PRODUCT BULLETIN

Material Change UE940

Foam Pick-up Hose for Large Body Eductor

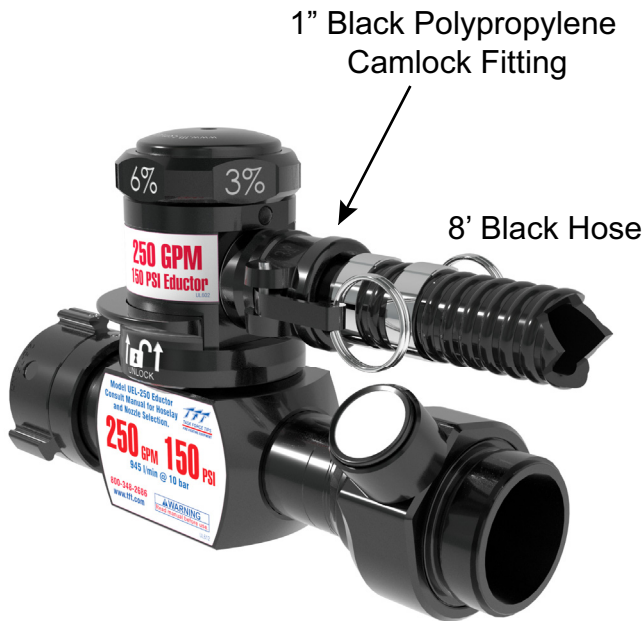
Standard order **UE940 Foam Pick-Up Hose** for all large body foam eductors is changed to **UE945** 8' long clear hose with a 1.0" black Polypropylene Female Camlock fitting. Optional black hose for high sun or extreme cold temperature applications is available as a special order accessory.

This change applies to all UE-1000-****, UE-1500-****, UE-250-****, UE-250L-****, UE-350-****, UE-350L-****, UE-800-****, and UEP-1000**** series eductors.
